## 7.7 Control Systems Not Required for Safety

The information in this section of the reference ABWR DCD, including all subsections and figures, is incorporated by reference with the following departures and supplements.

Figure 7.7-11 Simplified Functional Diagram of the Automatic Power Regulation System

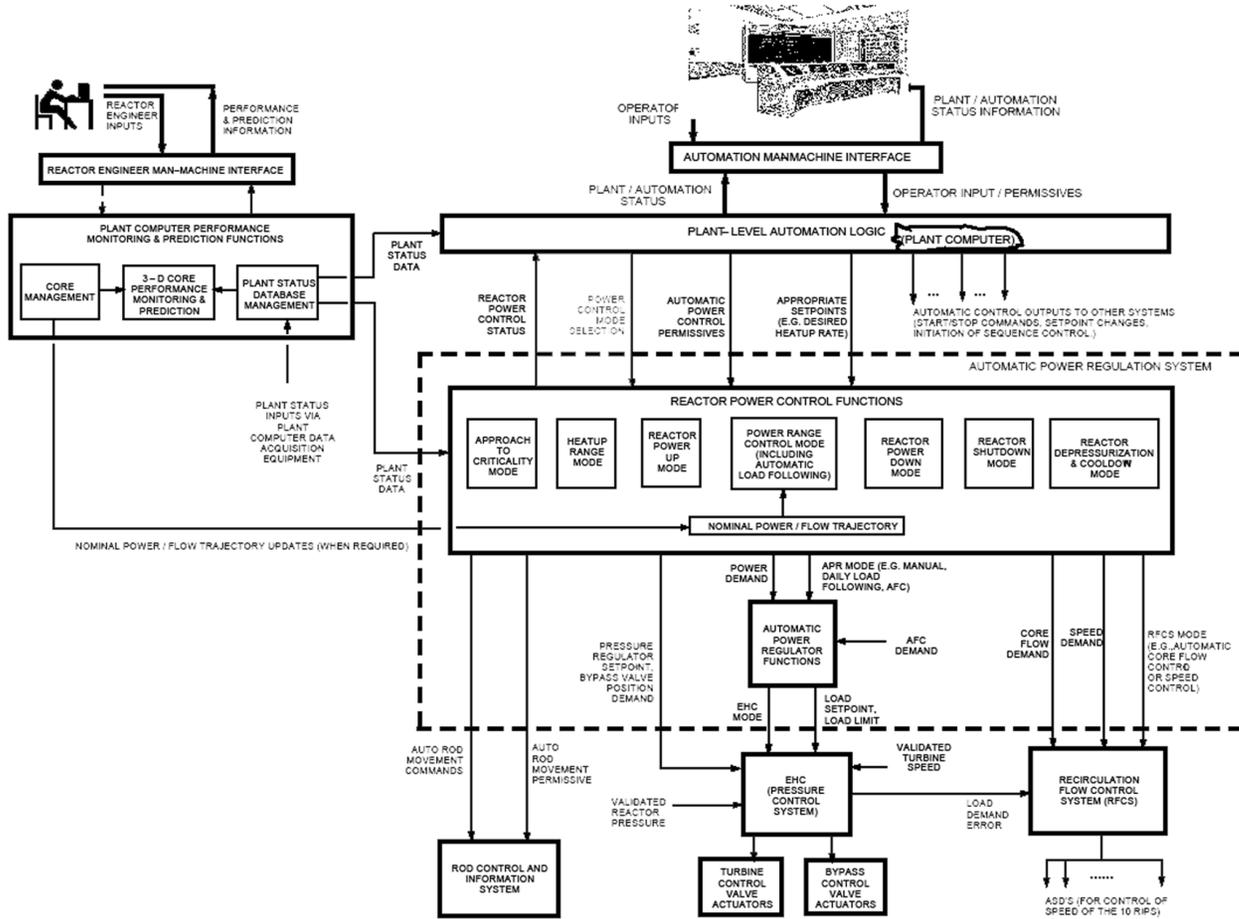
STD DEP T1 3.4-1 (Figures 7.7-2, 7.7-3, 7.7-4, 7.7-5, 7.7-7, 7.7-8, 7.7-9, 7.7-11)

*The primary objective of the Automatic Power Regulator (APR) System is to control reactor power during reactor startup, power generation, and reactor shutdown, by appropriate commands to change rod positions, or to change reactor recirculation flow. The secondary objective of the APR System is to control the pressure regulator setpoint (or turbine bypass valve position) during reactor heatup and depressurization (e.g., to control the reactor cooldown rate). The APR System consists of redundant process controllers. Automatic power regulation is achieved by appropriate control algorithms for different phases of the reactor operation which include approach to criticality, heatup, reactor power increase, automatic load following, reactor power decrease, and reactor depressurization and cooldown. The APR System receives input from the ~~plant~~ process computer, the Power Generation Control System (Subsection 7.7.1.5.42), the Steam Bypass and Pressure Control System (Subsection 7.7.1.8), and the operator's control console. The output demand signals from the APR System are to the RCIS to position the control rods, to the RFC System to change reactor coolant recirculation flow, and to the SB&PC System for automatic load following operations. The PGS performs the overall plant startup, power operation, and shutdown functions. The APR System performs only those functions associated with reactor power changes and with pressure regulator setpoint (or turbine bypass valve position) changes during reactor heatup or depressurization. A simplified functional block diagram of the APR System is provided in Figure 7.7-11.*
